ADDENDUM 3 REVISED: 08/20/07ab
REVISED: 05/21/07ab

DEMOLITION FLOOR PLANS

ST. TAMMANY PARISH ADMIN. COMPLEX
520 OLD SPANISH TRAIL
SLIDELL, LOUISIANA

RENOVATE OFFICE BUILDING

4TH FLOOR
DEMOLITION PLAN
SCALE: 1/8" = 1'-0"

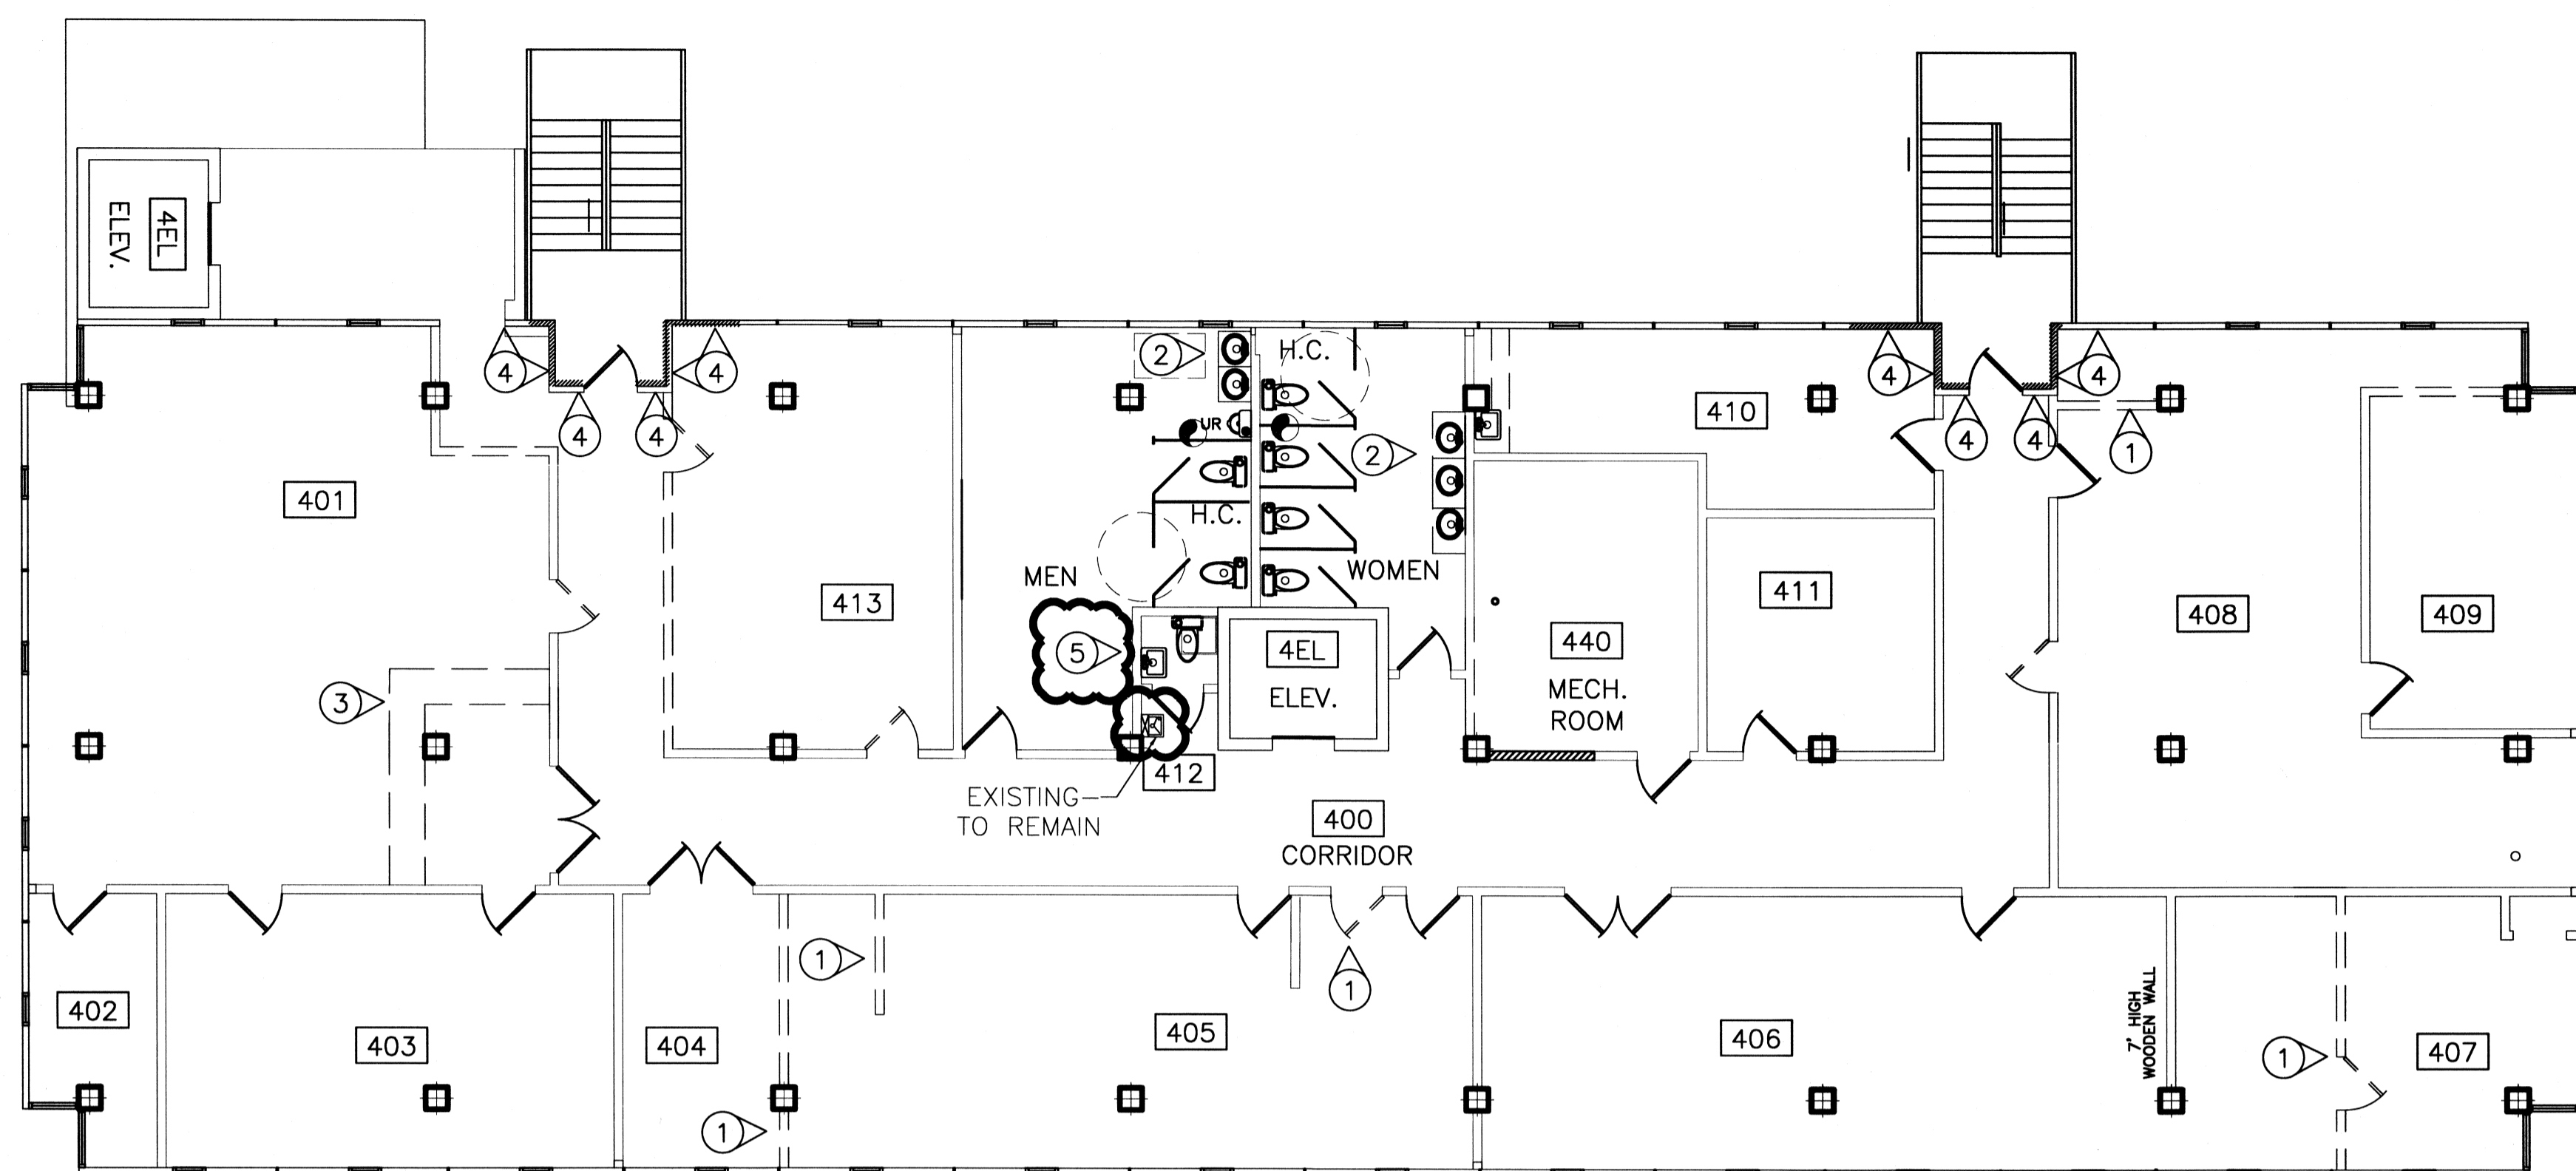
= ADDENDUM 3 CHANGE
